ACEEE Comments to the Environmental Protection Agency and the National Highway Traffic Safety Administration on the Technical Assessment Report; Docket ID No. EPA-HQ-OAR- 2015-0827 and/or Docket No. NHTSA-2016-0068

**Addendum to ACEEE Comments to the Environmental Protection Agency and the National Highway Traffic Safety Administration on the Technical Assessment Report;
Docket ID No. EPA-HQ-OAR- 2015-0827 and/or Docket No. NHTSA-2016-0068
November 17, 2016**

Figure 1: NHTSA’s technology penetration for selected full size pickups in MY 2028

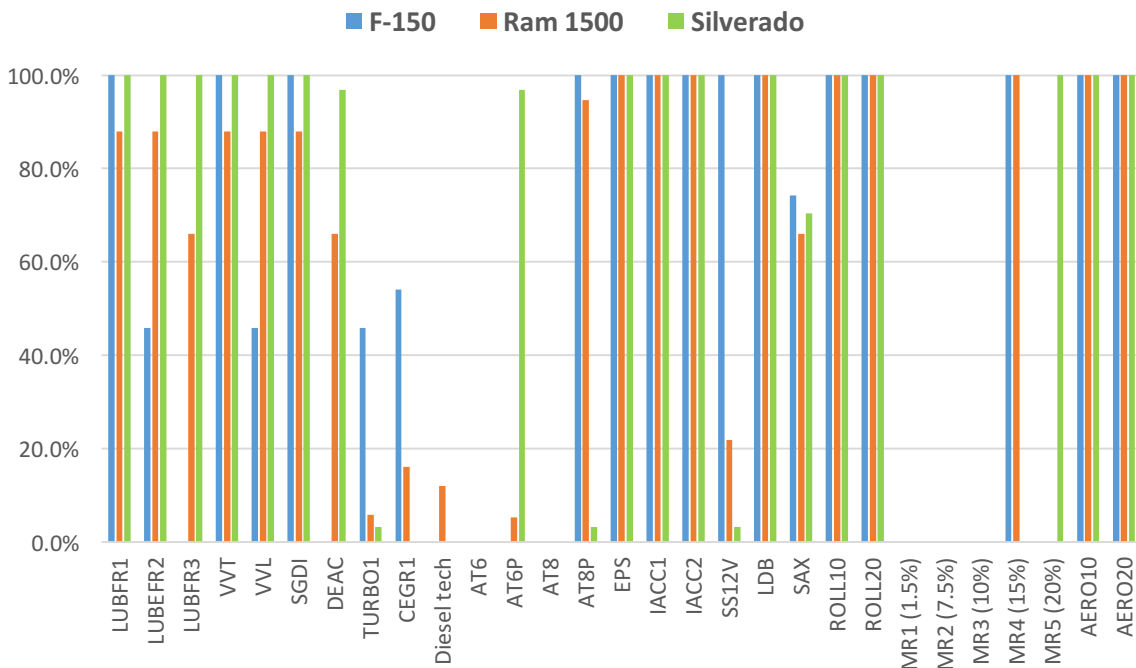
NHTSA’s compliance packages do not appear to show the most cost-effective pathways to compliance. For example, while there are 8-speed transmissions in almost all F-150 and Ram pickups in 2028, only 3% of Silverado trucks have them, the same percentage as in the 2015 baseline fleet. This is all the more surprising given that an 8-speed transmissions is already available in the high-volume 5.3L Silverado in MY 2016 and has been standard in models with the 6.2L engine for years.¹⁰

On the other hand, Volpe outputs show 100% of MY 2028 Silverado trucks with 20% mass reduction in 2028. Mass reduction will play a critical role for compliance for trucks, and all F-150 and Ram trucks, as well as the Silverado, will adopt 15% mass reduction by 2021, according to the model. But NHTSA’s cost estimates for mass reduction increase sharply at higher percent reduction, so increasing mass reduction to 20% in the Silverado before even adopting 8-speed transmissions is not plausible. Increasing mass reduction from 15% to 20% provides 3% fuel savings at a total cost of \$1,000 (p. 5–411), while an advanced 8-speed “plus” transmission (AT8P) gives 9% savings at a cost of \$320 (p. 5–298, p. 5–452).

The NHTSA compliance scenario also shows no hybrids, full or mild, in the F-150, Ram, or Silverado, even 48V mild hybrid provides fuel savings in the vicinity of 10% at a cost of about \$100 per percent fuel savings (pp. 5–301, 5–454). As noted previously, NHTSA does not explain its mild hybrid specifications or any limitations the Volpe model may place on adoption of this technology in the TAR, so it remains unclear why these vehicles do not appear in the
